PL/2023/07503 – Westbury and District Hospital, The Butts, Westbury, Wiltshire, BA13 3EL

We are writing in regards the proposal to vary conditions 5, 6 and 7 of 15/11604/OUT to become compliance conditions relating to the installed surface water drainage scheme and its associated maintenance regime.

This letter responds to the correspondence received from James Playfair on behalf of Wiltshire Council, dated 14th April 2026, and follows the Teams meeting held on 21st May 2026.

Photo 01 – Rear of properties adjacent farmer's field

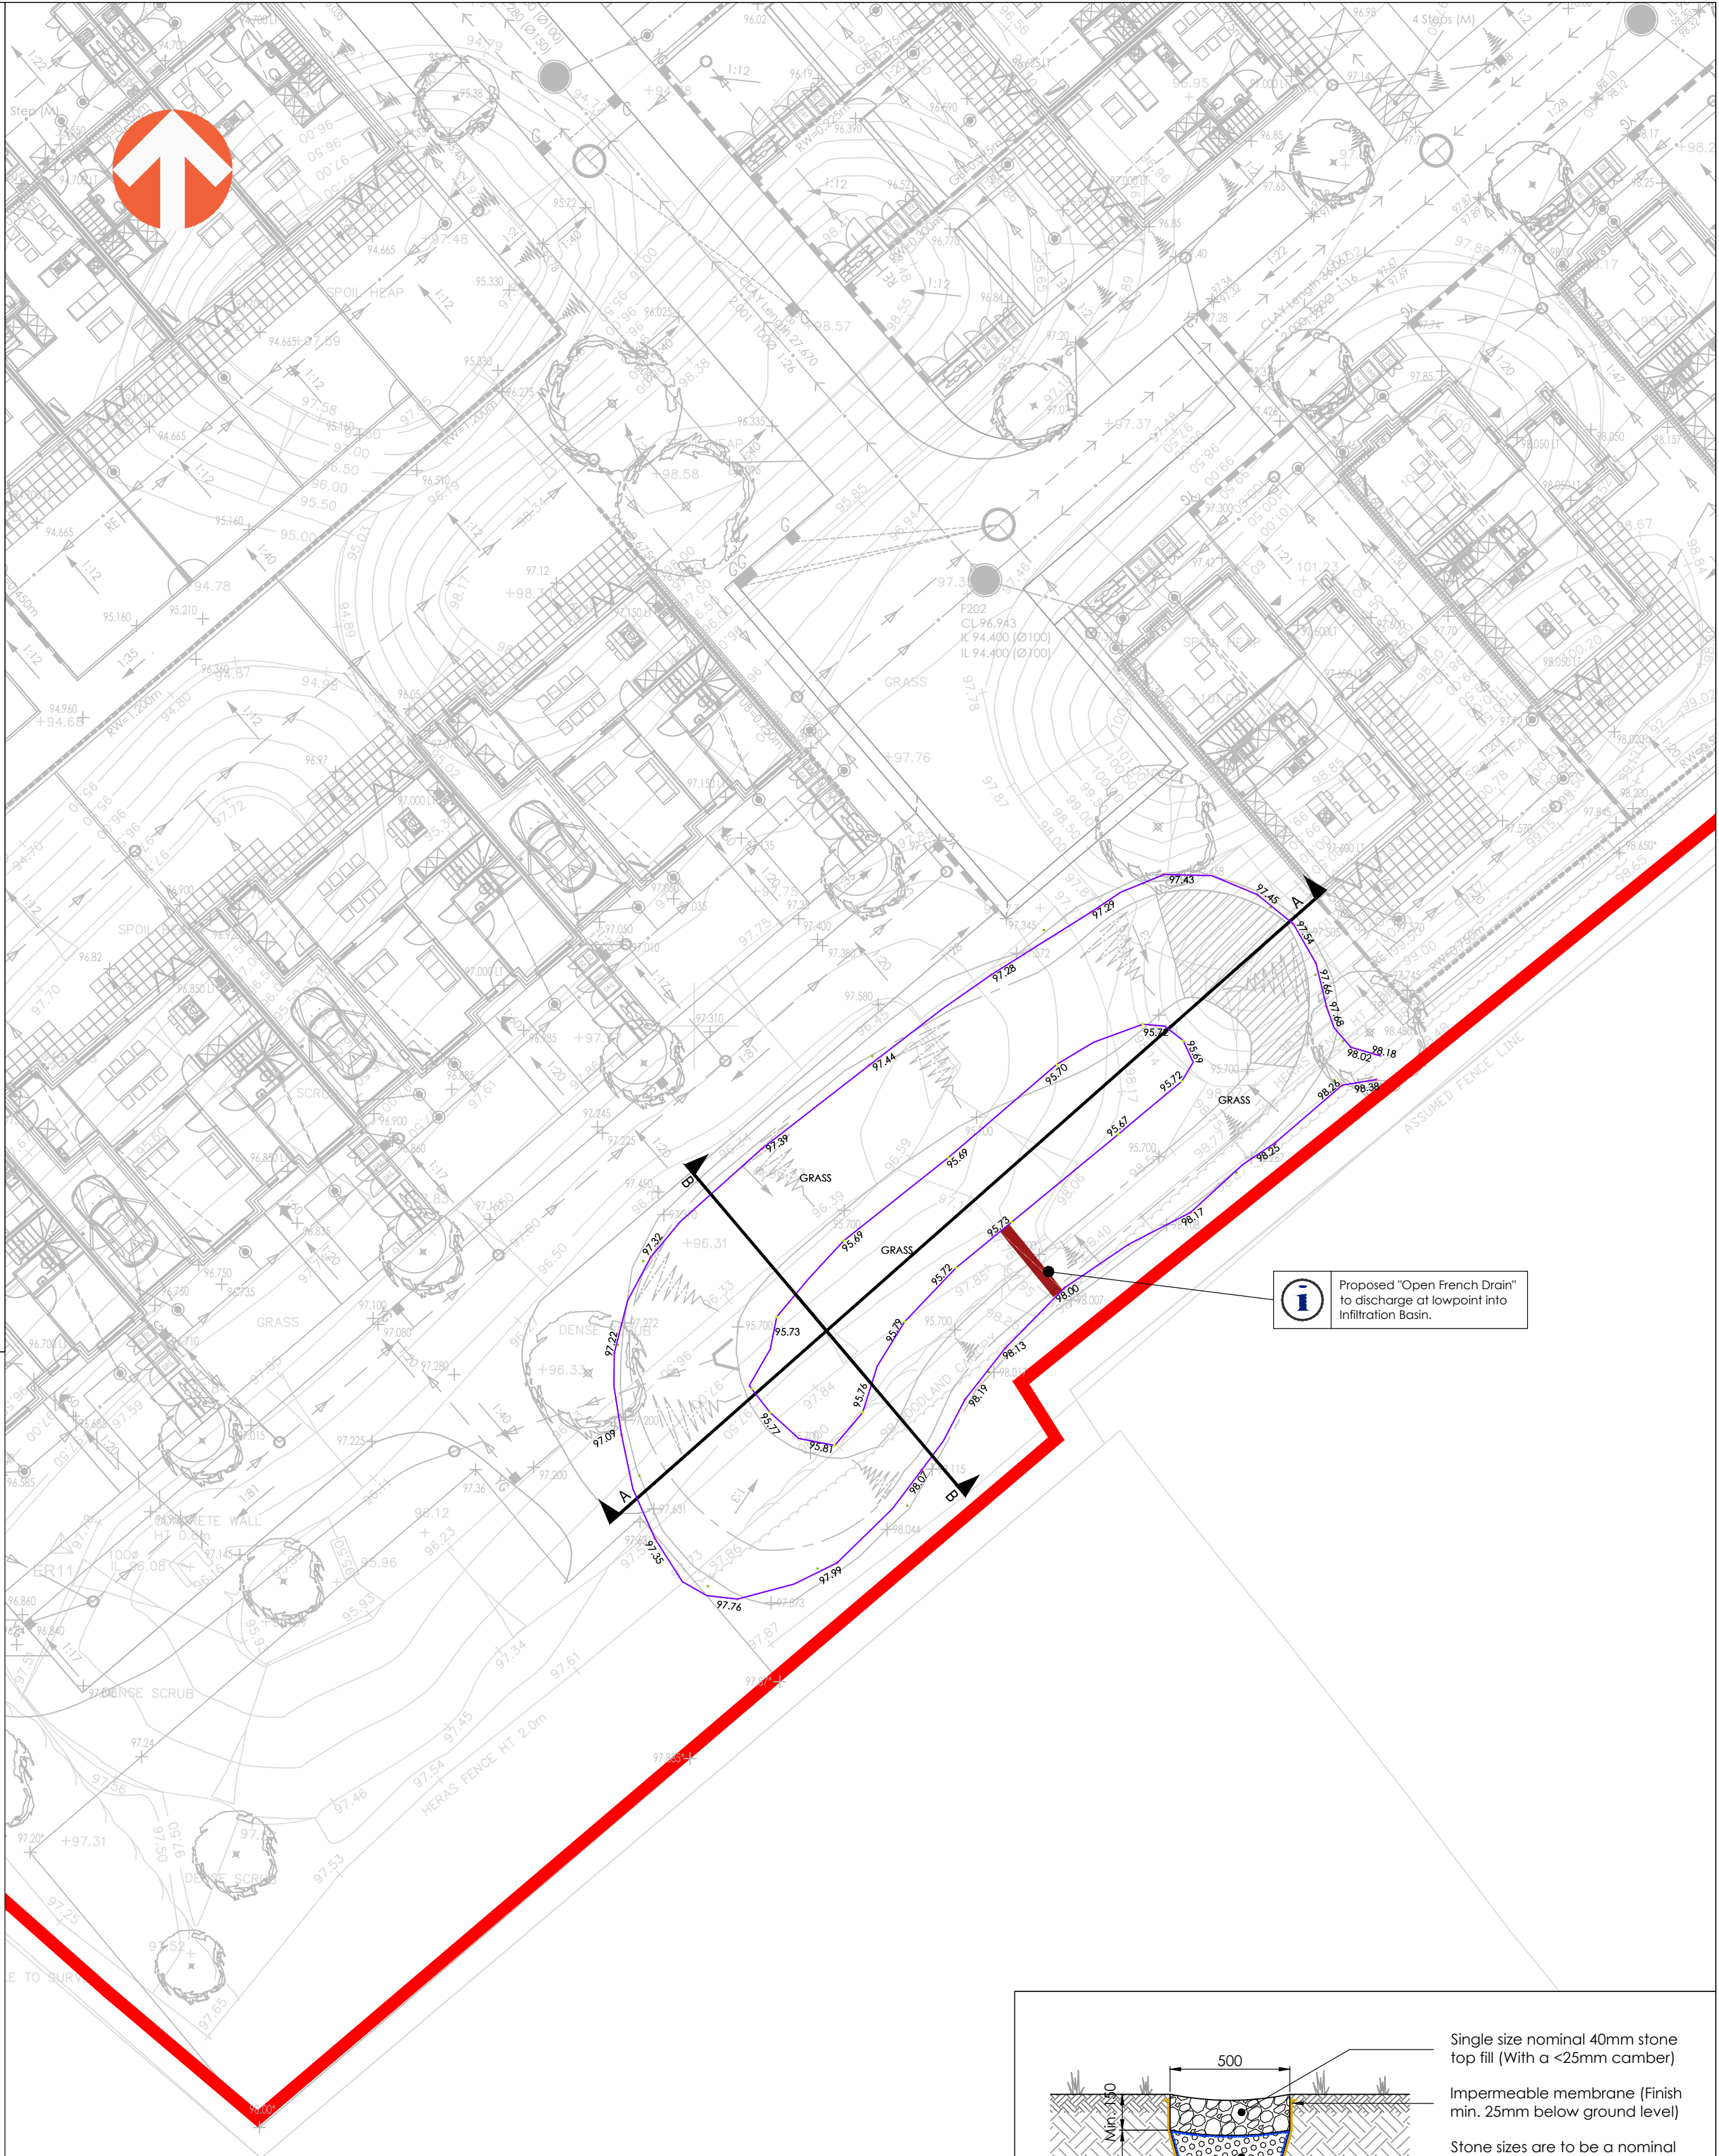
WC LLFA: Non-provision of a formal cut off swale behind house numbers 47 to 61 & Issued caused by overland flows from the adjacent farmer's field and recreation ground

As discussed during our meeting, the evidence base clearly demonstrates that surface runoff from the upstream agricultural land is being channelled through the lower edge of field by the existing well-established hedgebank. The strip of land immediately downstream of the hedgebank shows no signs of surface runoff, erosion or scour (Photo 01).
